Hamza Clothing Ltd.

Bangabandhu Road, Tongabari, Ashulia

26th August & 7th September 2021

Observations

DEA documents need to be reviewed by RSC

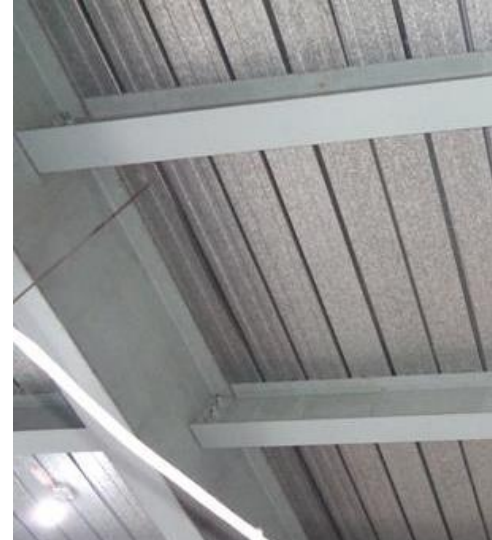
Factory performed DEA and as per recommendation of DEA, factory completed the retrofitting works. In DEA report connection adequacy has not been provided for any type of connection. Factory engineer is required to provide the connection adequacy check for all types of connections in DEA report which is required to be reviewed by RSC.

Stair(1-4) column Schedule

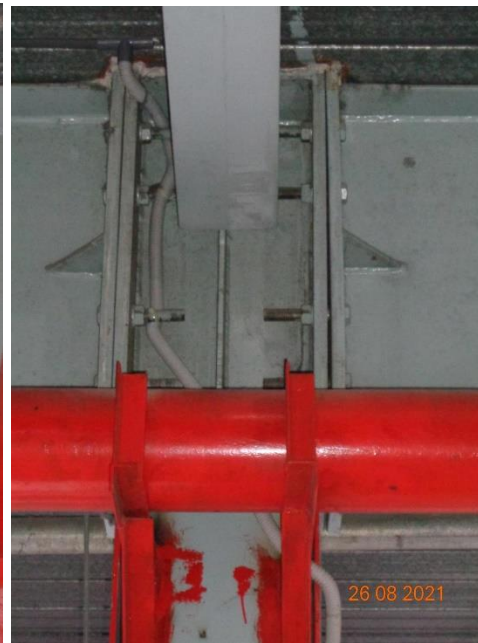
Least dimension of the column for stair (1-4) was found 250mm and for the stair-5 was found 300mm

Ground Floor

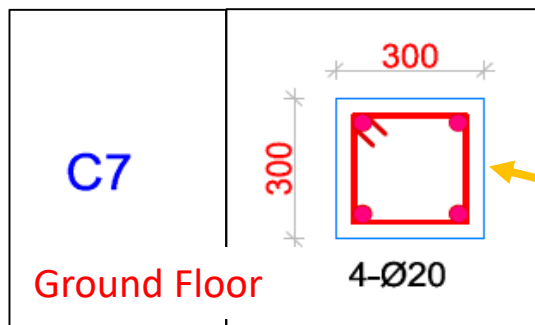
Ground floor column for the stair (1-4) was found 4.45 m (least one) in unsupported length and least dimension 250 mm in size. And the ground floor column for the near stair-5 was found 4.67 (unsupported length) and dimension 300mm. The unsupported length/width=17.52 for stair (1-4) and unsupported length/width=15.67 for the stair-5 indicate that the columns are critical for slenderness effect. So, the factory engineer is required to check and address this issue in the DEA report.

Stair(1-4) column Schedule

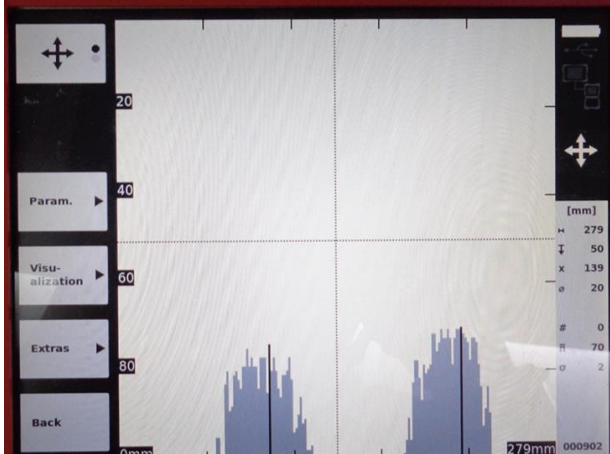
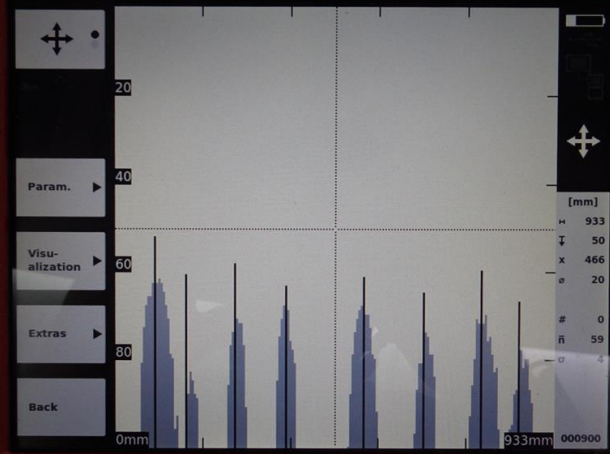
From the ferro-scanning, 8 nos re-bar in long face (left image) and 2 nos re-bar in short face (right image) was found.

Number of re-bar was found mismatch in between as built drawing and actual site condition. Total 20 nos re-bar has been shown in drawing. But from the ferro-scanning, total 16 nos of re-bar was found. Factory engineer is required to survey the who structure and update the as-built drawing as per site condition.

Orientation of marked column found mismatched

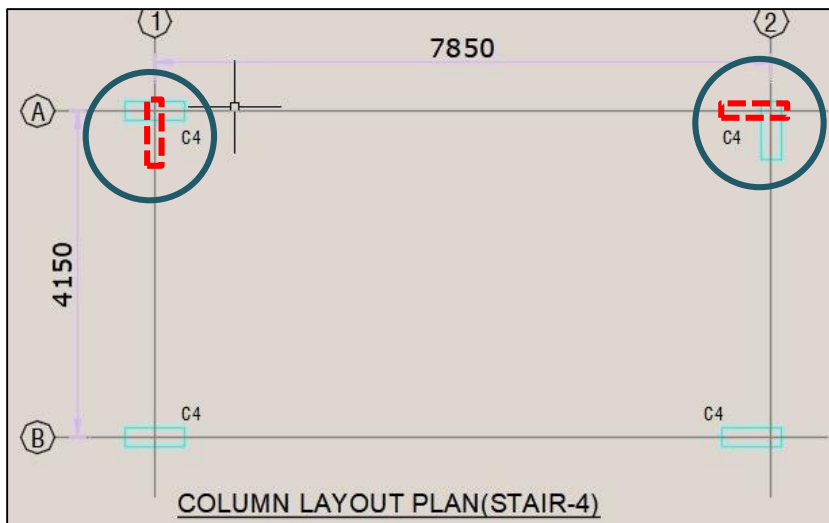
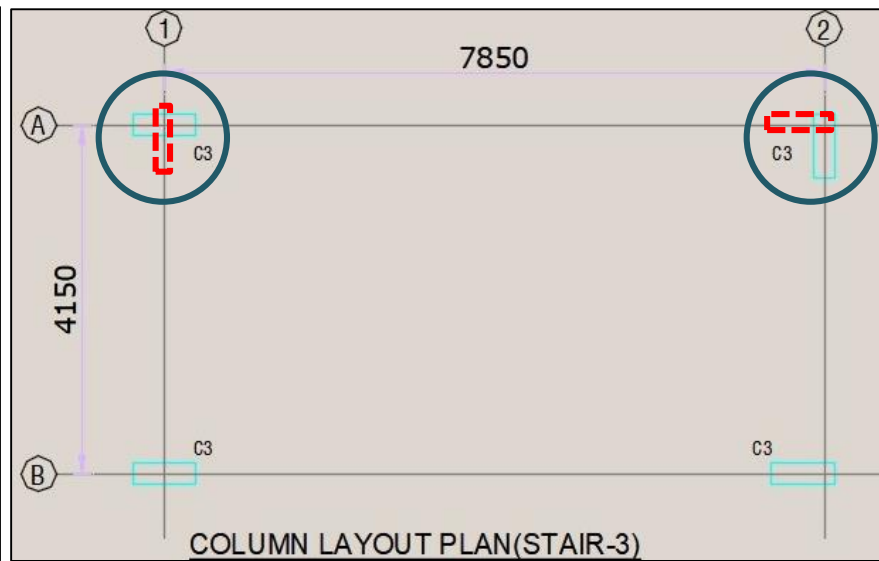
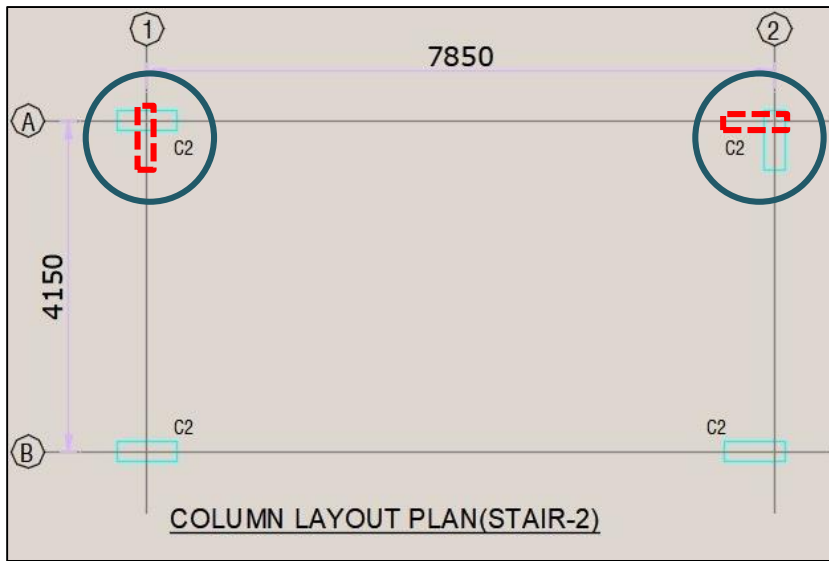
Orientation of the column does not match with as built drawing. Column orientation was found as per the dotted red marked.

Mis-match found between the as-built drawing and actual site condition. Column orientation does not match with at marked location. Factory engineer is required to survey the whole structure and update as-built drawing.

C4- column schedule.

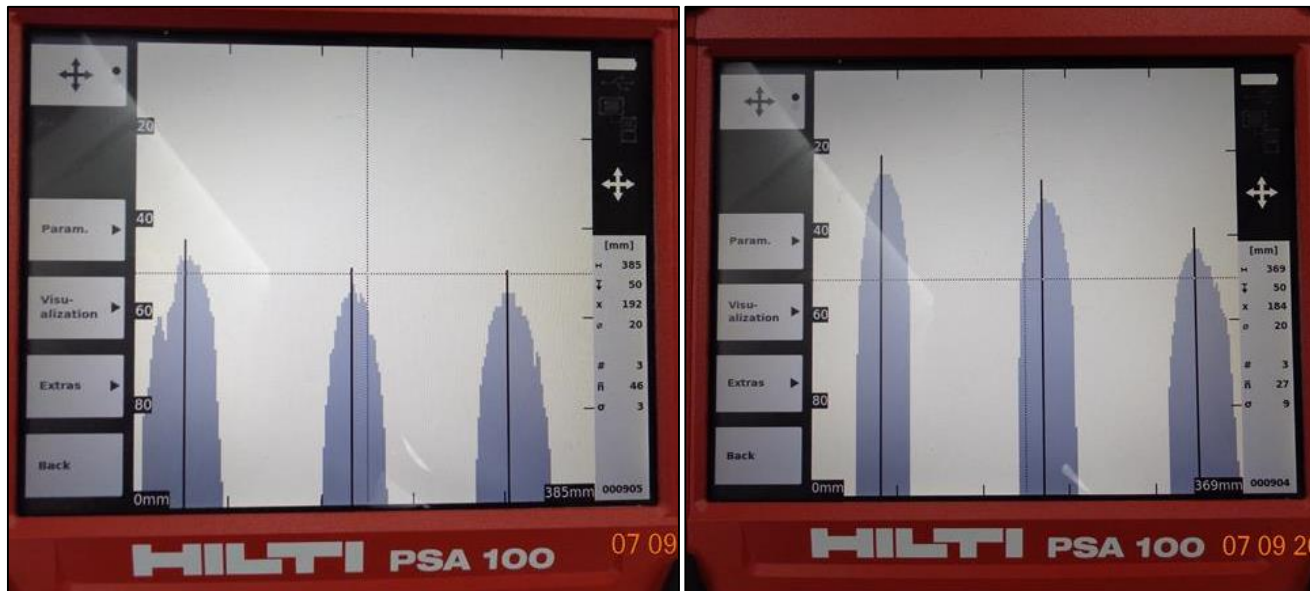
In as built drawing, column re-bar has been shown 4 nos in one face & 3 nos in another face.

Number of re-bar was found mismatch in between as built drawing and actual site condition. Total 10 nos re-bar has been shown in drawing. But from the ferro-scanning, total 8 nos of re-bar was found. Factory engineer is required to survey the whole structure and update the as-built drawing as per site condition and also check the column capacity.

From the ferro-scanning, 3 nos re-bar was found each face of the column.

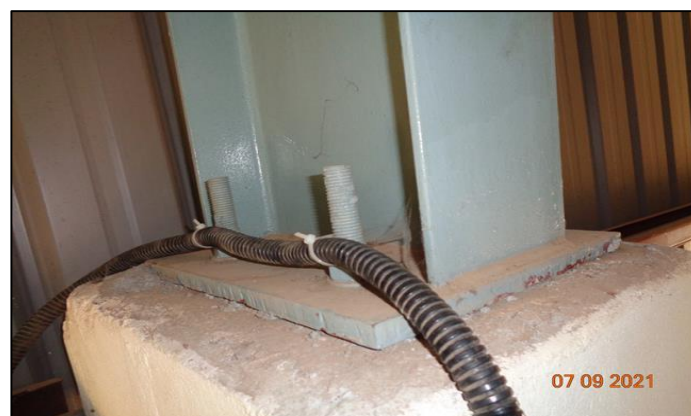
Roof bracing is made of 25mm dia re-bar is connected with rafter by welding. Adequacy check of the connection has not been provided in DEA report

Connection of the roof bracing seems to be inadequate.

Factory engineer is required to update the DEA report providing the adequacy check for all types of connections.

Truss roof System

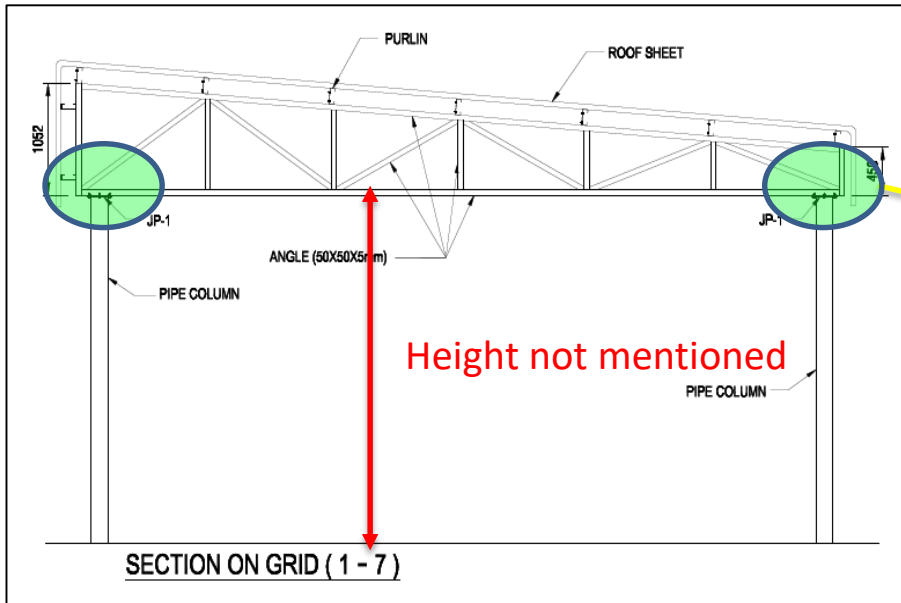
The steel roof truss is supported by steel pipe column. No vertical & roof bracing was found. As a result, there is no apparent load path to transfer the lateral loading along the long direction. Building Engineer is required to check the lateral stability of the steel shed and check the adequacy of the connection.

Truss roof System

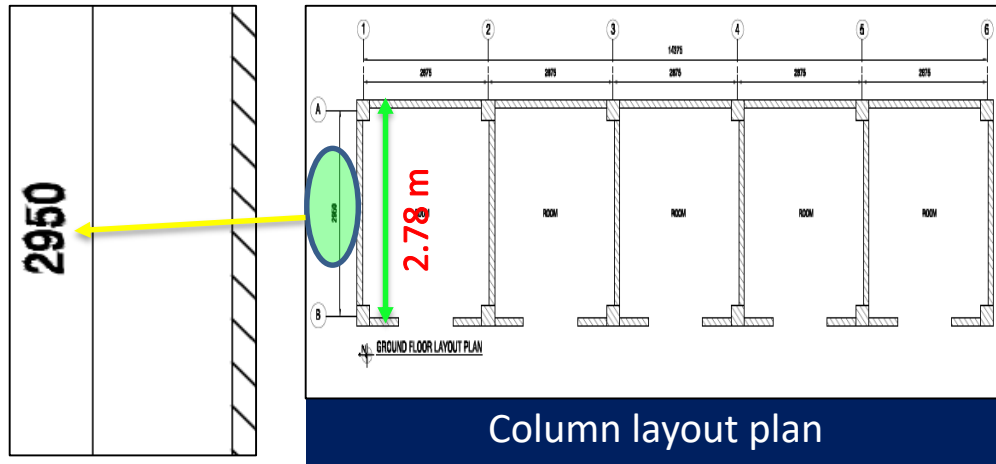
The steel roof truss is supported by brick column. No vertical & roof bracing was found. As a result, there is no apparent load path to transfer the lateral loading along the long direction. Building Engineer is required to check the lateral stability of the steel shed and check the adequacy of the connection.

Discrepancies in as-built drawing

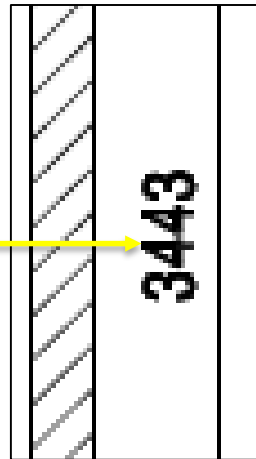
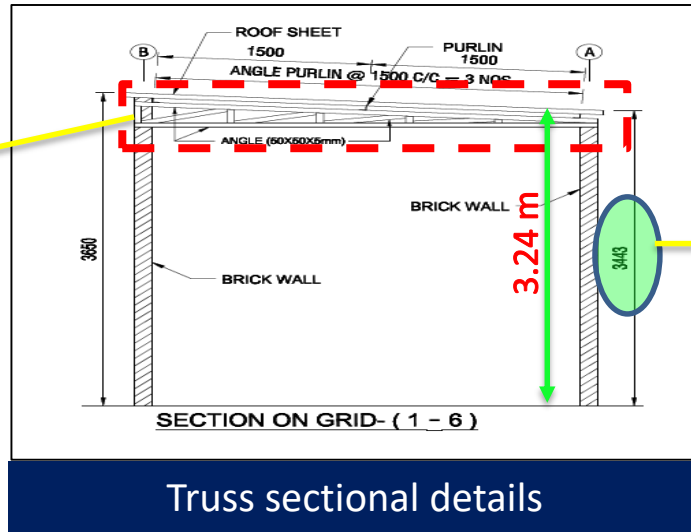
In as-built drawing short direction dimension was mentioned as 2.95 m. But dimension was found 2.78 m.

Orientation of truss diagonal members were found different from as-built drawing. Also, shed height at grid A was mentioned 3.44 m. But height was found 3.24 m. Building Engineer is required to survey the whole structure and prepare accurate as-built (both architectural & structural) drawings.

Discrepancies in as-built drawing

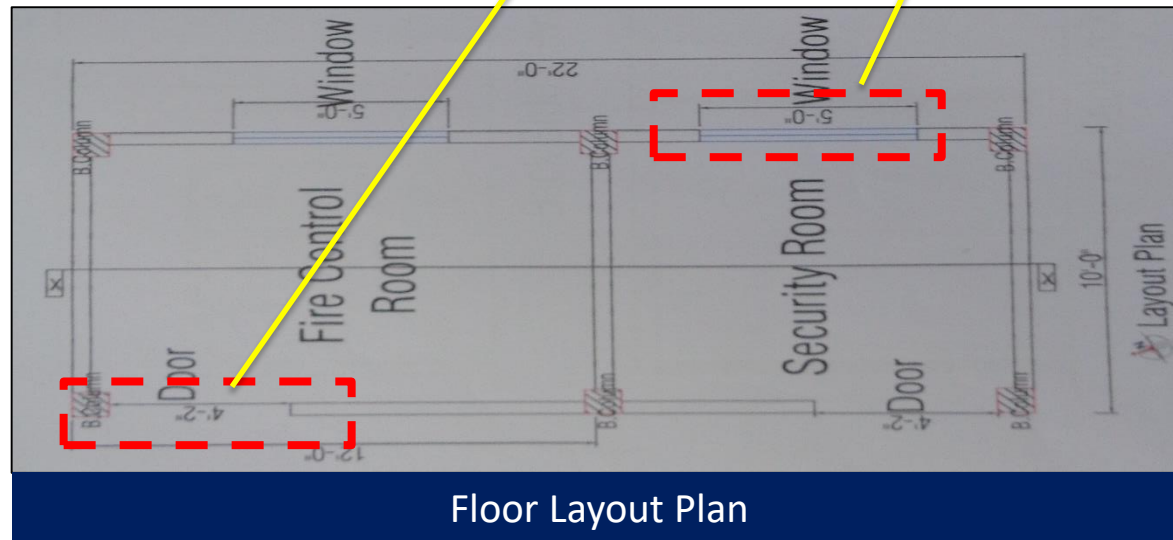
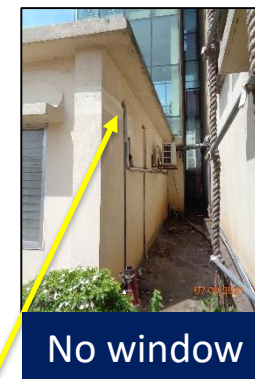
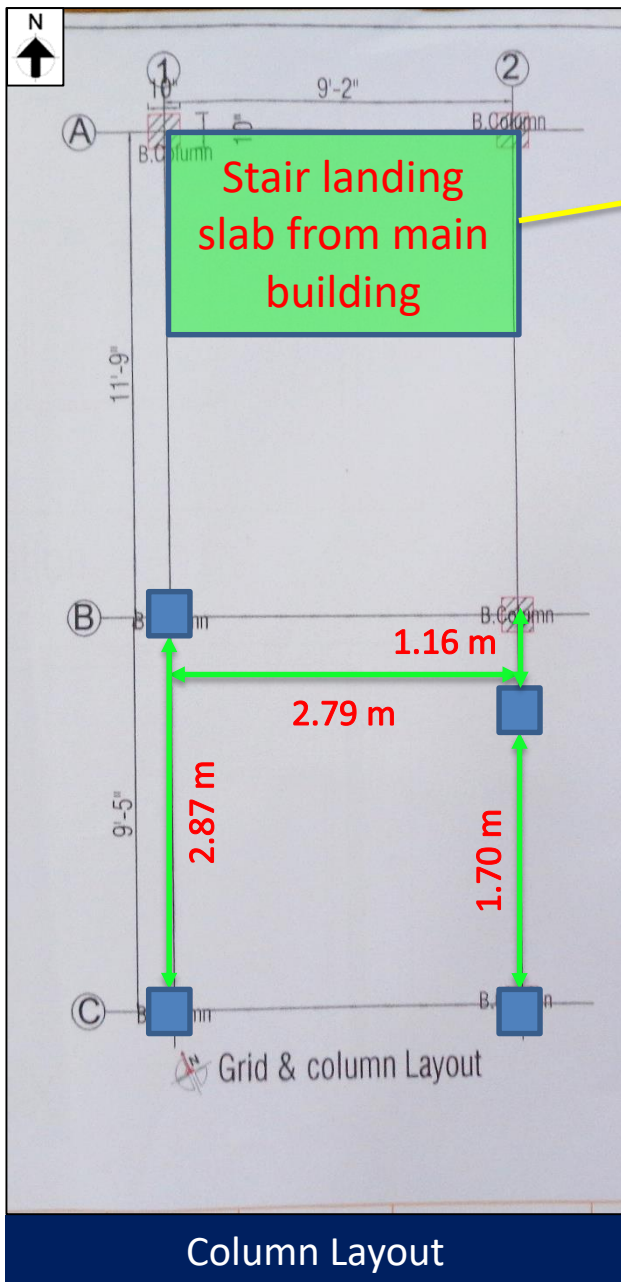
Grid dimension, column position, door & window position do not match with as-built drawing. Building Engineer is required to survey the whole structure and prepare accurate as-built (both architectural & structural) drawings.
